SIMOND Recalls ALPINISM & VERTIKA Quickdraws**Affected Products:**

- Alpinism Quickdraw 11 cm (4051175)
- Alpinism Quickdraw 17 cm (4051176)
- Pack of 5 Alpinism Quickdraws (4171656)
- Vertika Quickdraw 11 cm (5499689)
- Vertika Quickdraw 17 cm (5500194)

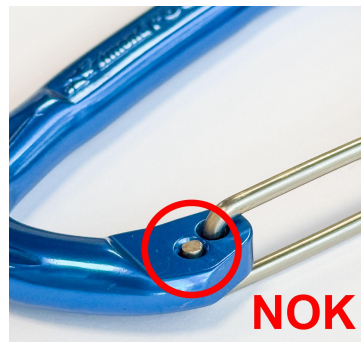
We have identified a defect in the wire gate riveting on these carabiners. This assembly fault can cause the wire gate to break or detach, posing a serious risk of carabiner failure in the event of a fall.

OK / SAFE: Correct riveting — rounded end in a "mushroom" shape.

DEFECTIVE / NOT OK: Defective riveting — flat end.

Stop using your quickdraw immediately.

Any defective quickdraw returned to a Decathlon store will be refunded in full at the original purchase price.
